PROJECT NAME: WAITSFIELD

PROJECT NUMBER: BF 013-4(39)

FILE NAME: z12b136quantity.xlsm PLOT DATE: 10/13/2015
 PROJECT LEADER: R.YOUNG DRAWN BY: S. MERKWAN
 DESIGNED BY: VTRANS/D.KULL CHECKED BY: T.KENDRICK
PRELIMINARY INFORMATION SHEET 1 SHEET 2 OF 69

REV	DATE	DESCRIPTION	AS BUILT "REBAR" DETAIL		
			LEVEL I	LEVEL II	LEVEL III
△	10/13/15	SHEET ADDITIONS	TYPE:	TYPE:	TYPE:
△		MODIFICATIONS FOR CHANGED DECK TYPE	GRADE:	GRADE:	GRADE:

TYPICAL BRIDGE SECTION
SCALE 3/8" = 1'-0"

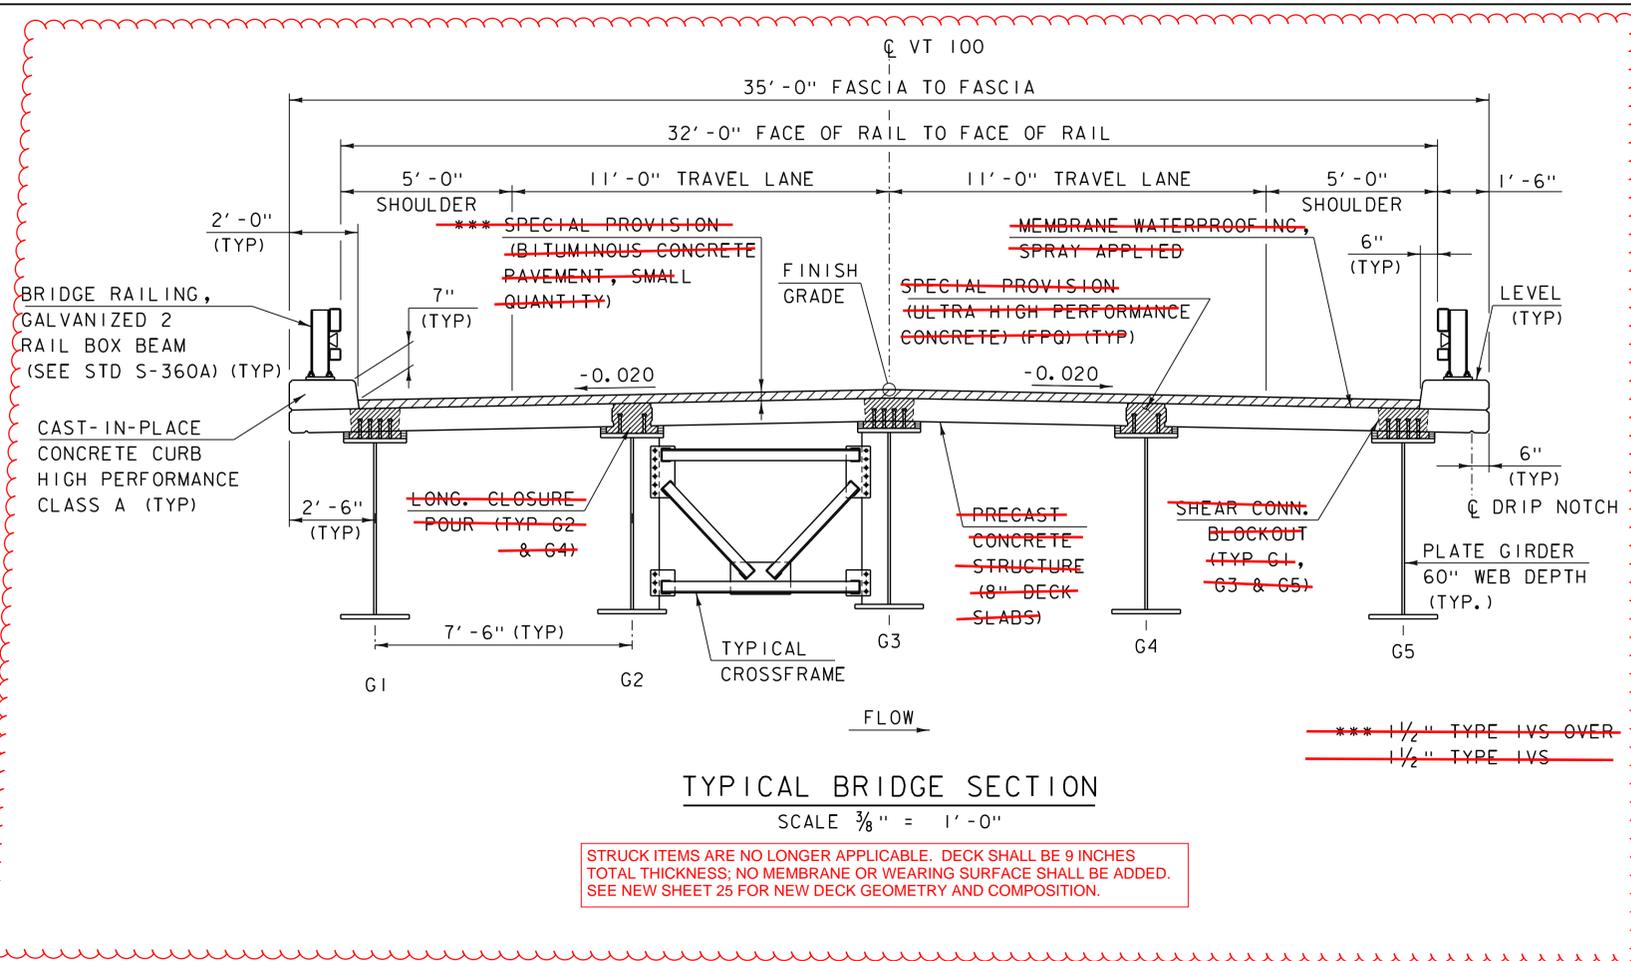
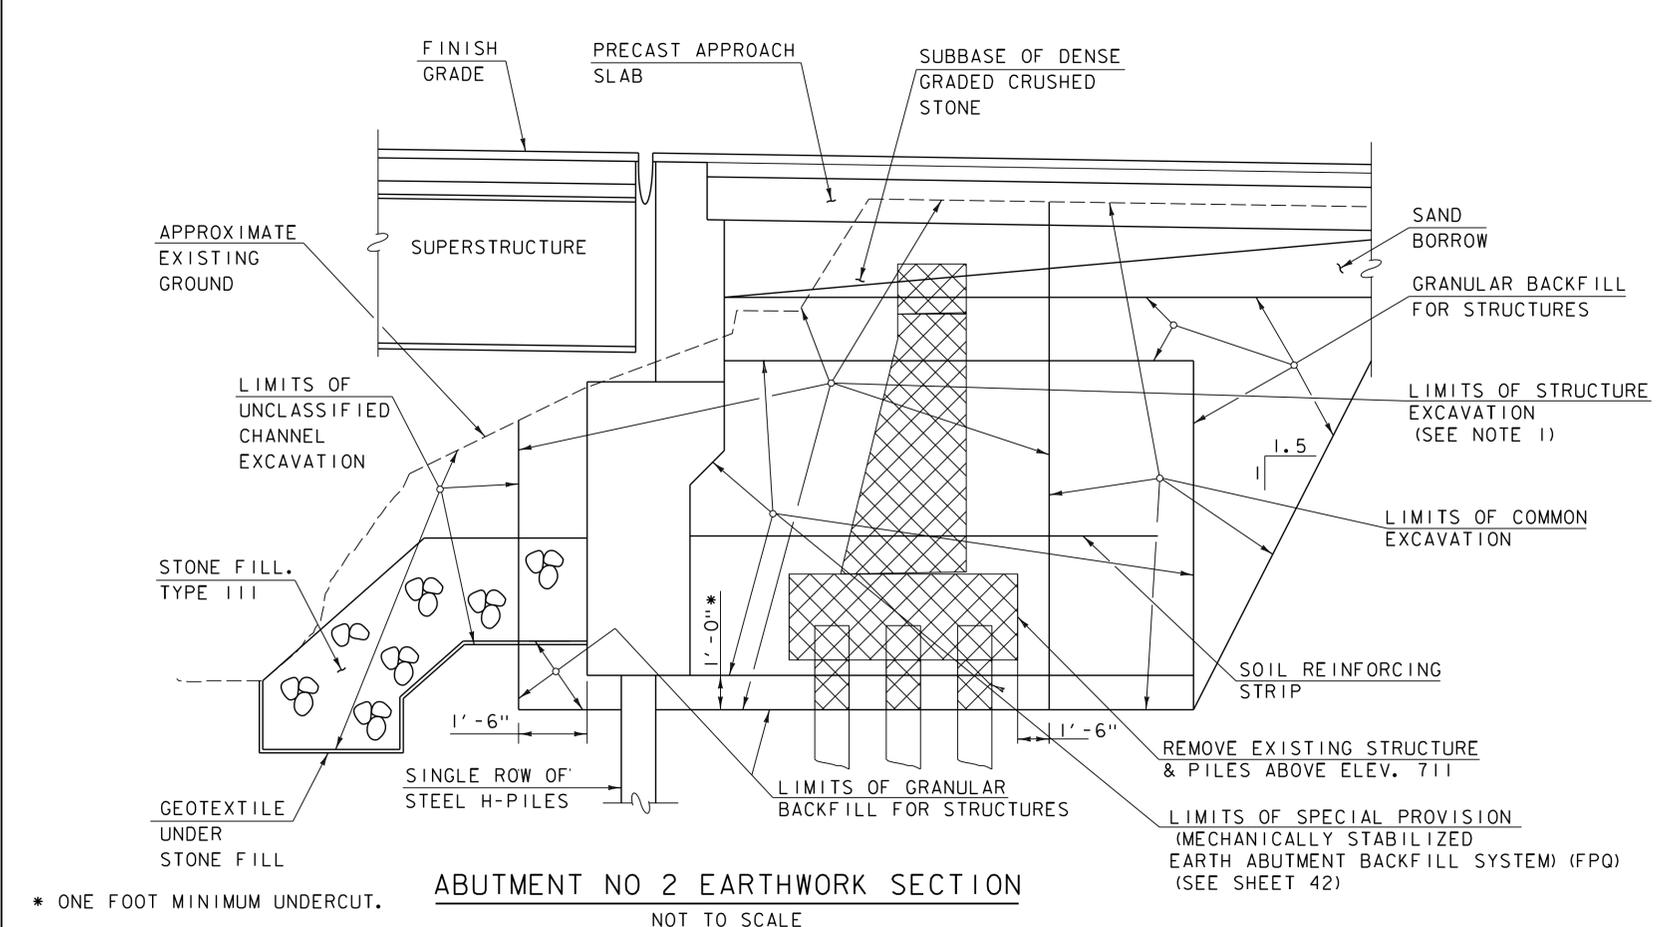
STRUCK ITEMS ARE NO LONGER APPLICABLE. DECK SHALL BE 9 INCHES TOTAL THICKNESS; NO MEMBRANE OR WEARING SURFACE SHALL BE ADDED. SEE NEW SHEET 25 FOR NEW DECK GEOMETRY AND COMPOSITION.

PRECAST DECK PANEL LAYOUT

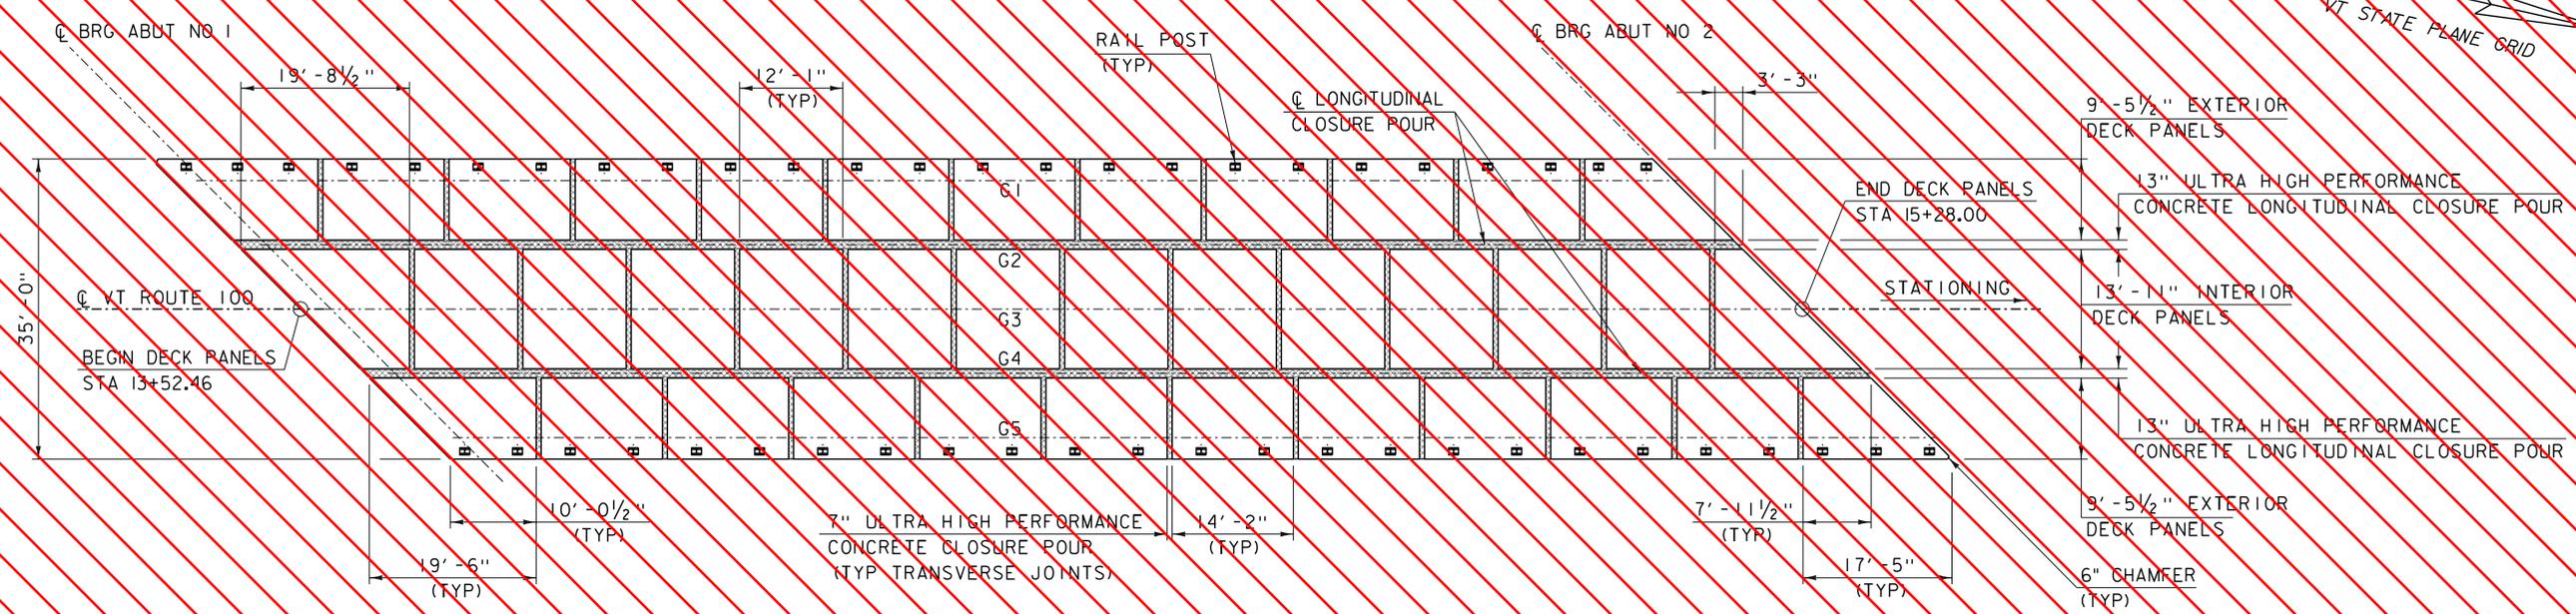
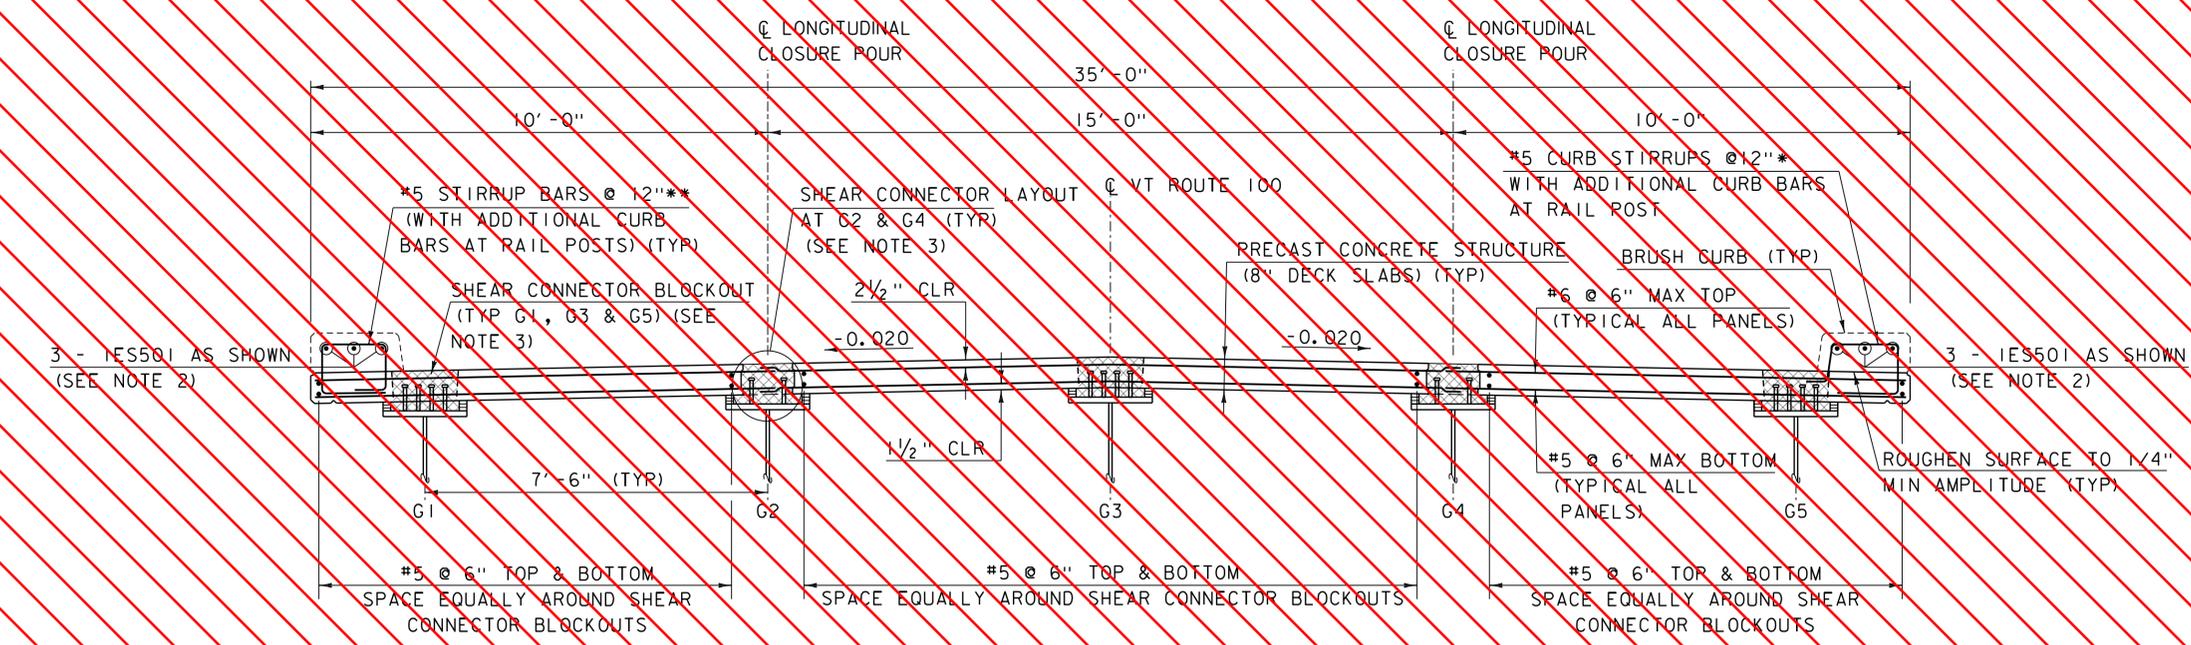
SEE REVISED SHEET 25 BY T.Y. LIN INTERNATIONAL

TYPICAL EXTERIOR PANEL REINFORCEMENT PLAN
 (FASCIA PANEL SHOWN, INTERIOR PANEL SIMILAR)
 SCALE: 3/4" = 1'-0"

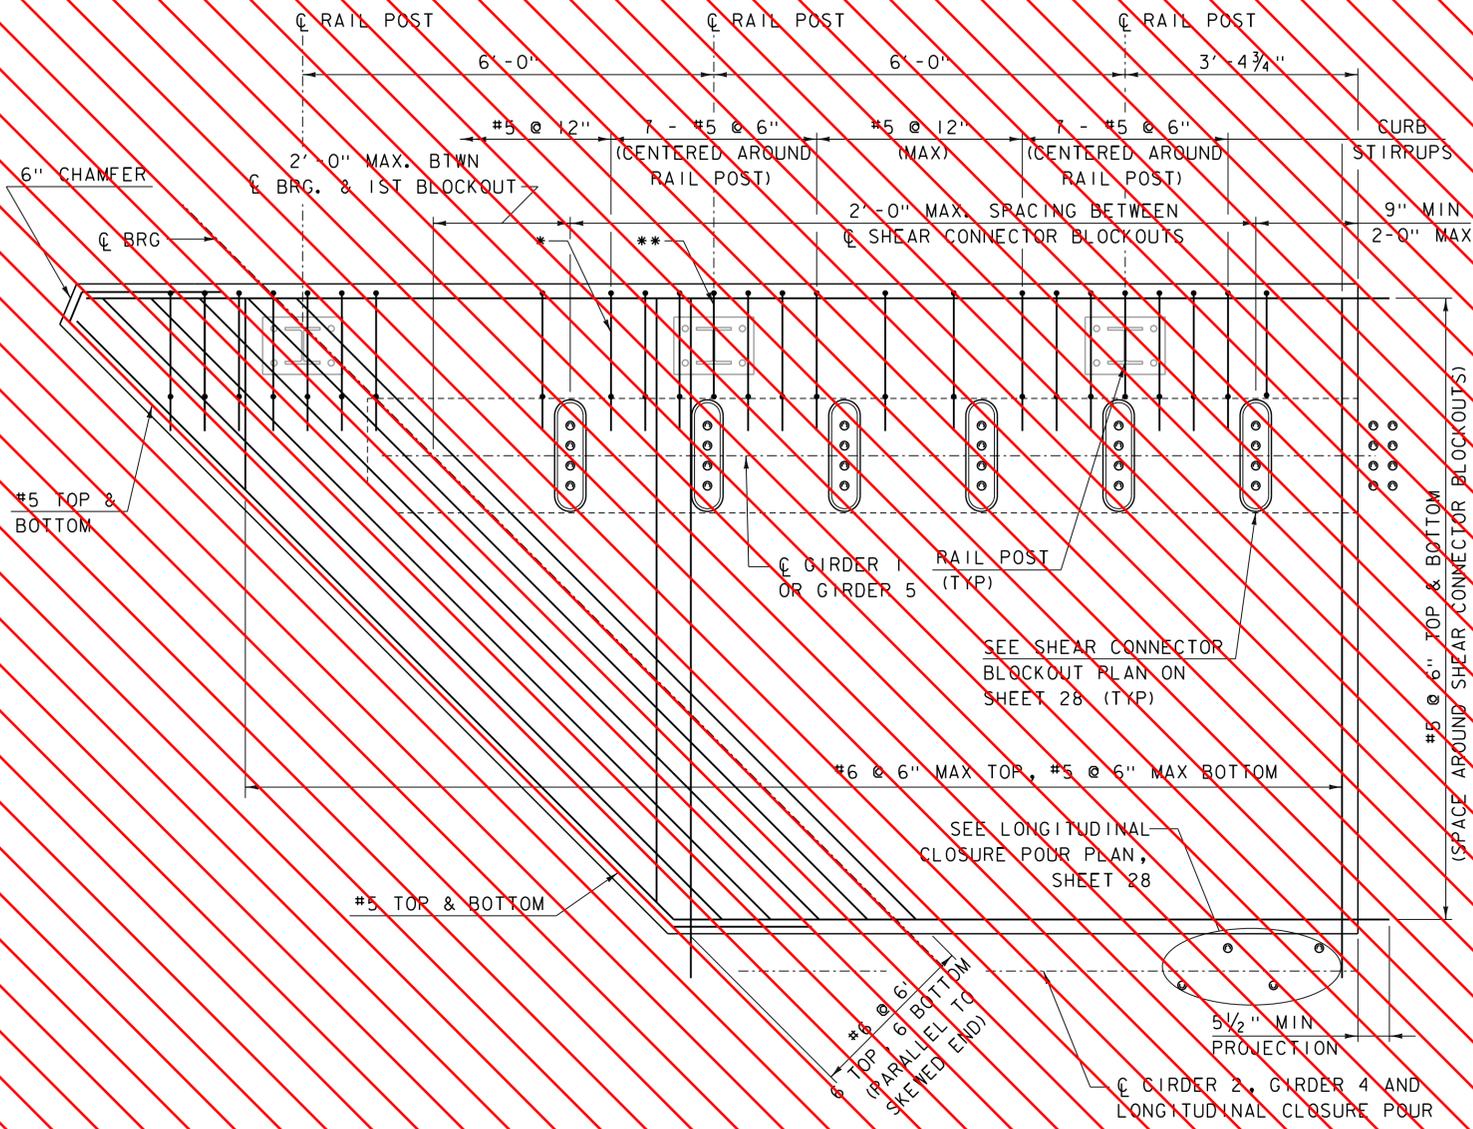
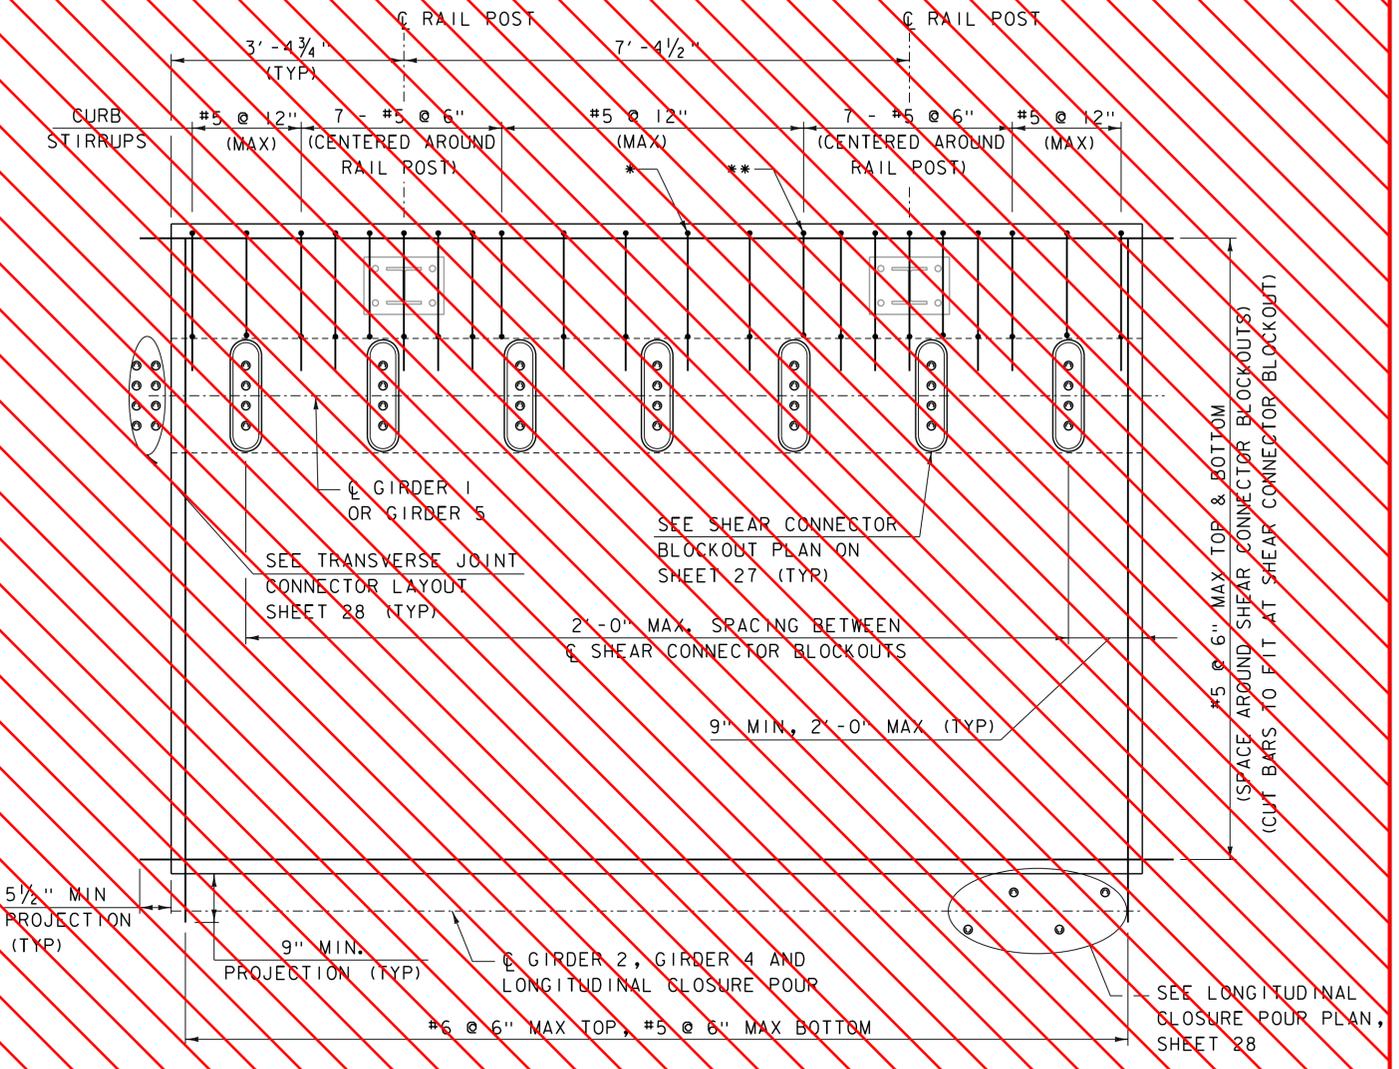
SEE REVISED SHEET 26 BY T.Y. LIN INTERNATIONAL

PROJECT NAME:	WAITSFIELD	PLOT DATE:	8/24/2015
PROJECT NUMBER:	BRF 013-4(39)	DRAWN BY:	S.MERKWAN
FILE NAME:	I2b36sup Fram.dgn	DESIGNED BY:	D. KULL
PROJECT LEADER:	R. YOUNG	CHECKED BY:	T. KENDRICK
CAMBER DETAILS		SHEET	32 OF 69

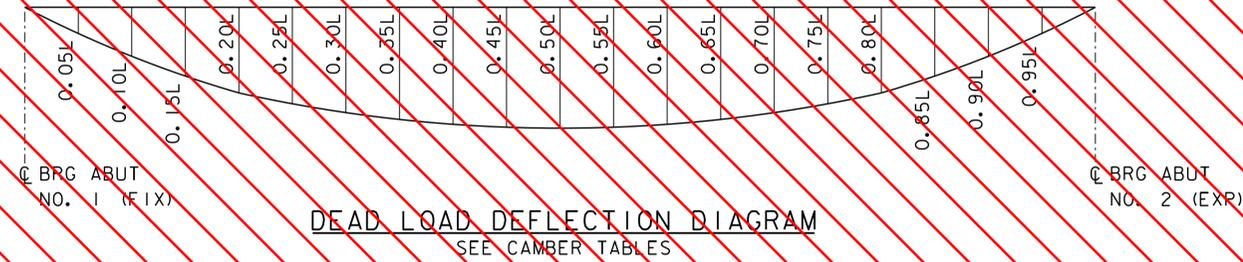
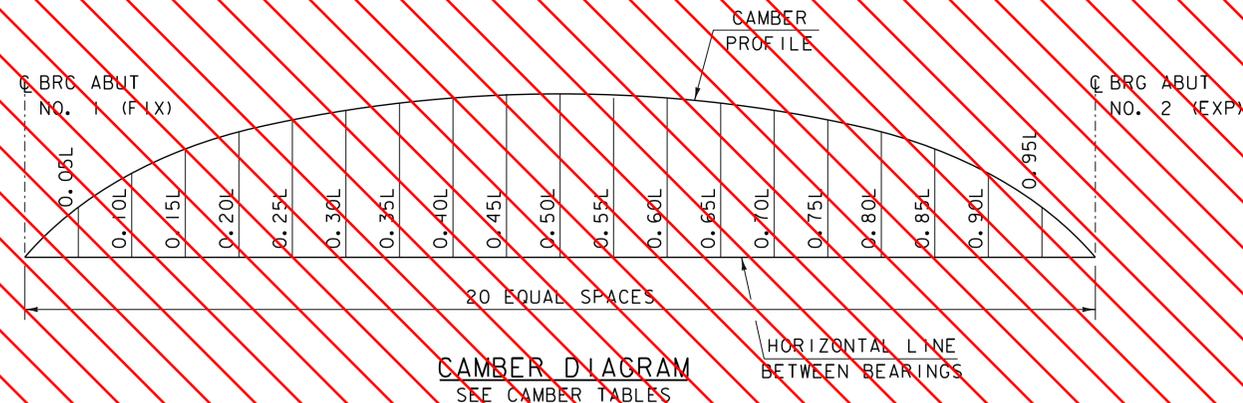
SEE REVISED SHEET 32 BY T.Y. LIN INTERNATIONAL
